## WORK ORDER NON-CONFORMANCE / UPDATE

Work Order: <u>90367</u>				DISPOSITION		AGAINST DEPARTMENT/PROCESS									
Part No. <u>D4154-1</u>				Rework <input checked="" type="checkbox"/> Scrap <input type="checkbox"/> Use-as-is <input type="checkbox"/> Work Order Update <input type="checkbox"/>		Skid-tube <input type="checkbox"/> Machining <input type="checkbox"/> Thermoforming <input type="checkbox"/> Large Fab <input type="checkbox"/> Crosstube <input type="checkbox"/> Small Fab <input type="checkbox"/> Finishing <input type="checkbox"/> Composite <input type="checkbox"/> Water Jet <input checked="" type="checkbox"/> Prod. Eng. Coord. <input type="checkbox"/> Rec/Store/Packaging <input type="checkbox"/> Supplier <input type="checkbox"/> Engineering <input type="checkbox"/> Quality <input type="checkbox"/> Other <input type="checkbox"/>									
NCR No. <u>12-1849</u>

DESIGN	SC	DART AEROSPACE USA, INC.	
DRAWN	AJS	KENT, VA	
CHECKED	JP	DRAWING NO.	REV. E
MFG. APPR.	JD	D4154	SHEET 3 OF 4
APPROVED	JD	TITLE	SCALE
DE APPR.	JD	WEARPLATE ASSEMBLY	NTS
DATE	12.08.07	<small>           COPYRIGHT © 2010 BY DART AEROSPACE USA, INC.            THIS DOCUMENT IS PRIVATE AND CONFIDENTIAL AND IS SU

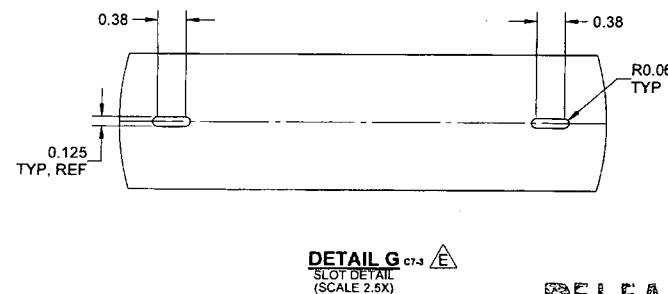
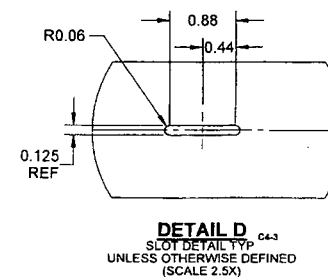
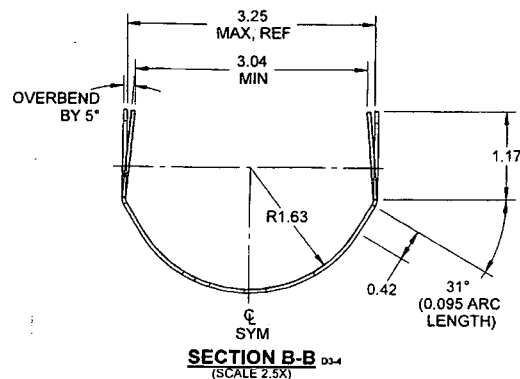
Root Cause	Date	Step	Qty	Description of work order update or Non-conformance	Initial Chief Eng	Action Description	Sign & Date	Verification	QC Inspector
Doc/Data	12-09-03	100	12	SAME Ø0.516" HOLES ARE TOO SMALL IN ONE DIRECTION (FWD TO AFT). THIS COULD BE A PROBLEM ON ASSY/INSTALL DUE TO WARPING WHEN WELDING.		BULGERS HOLES TO SIZE: Ø0.516 <sup>+0.002</sup> -0.000	JM 12-9-20	SMB 12-9-20	 12-09-20
Equip/Tooling									
Operator									
Material									
Setup									
Other									
Process									
Supplier									
Training									
Unapproved
